ADDENDUM NO. 1

2026 STEWART COUNTY AGRICULTURAL PAVILION STEWART COUNTY, TENNESSEE

Project #: SC-2026-2

Figure 1. Updated Legend

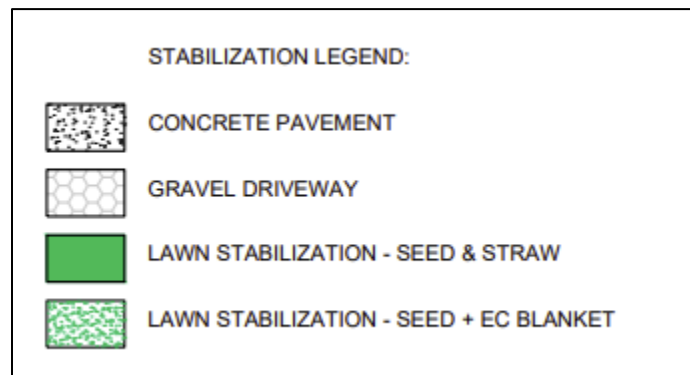
Item #3 On C4.03 the legend shows **“LAWN STABILIZATION – SEED + EPSC BLANKET”** as a black shade entirely. However, it is meant to be the green speckled fill as shown in the plan and shown in the figure below.
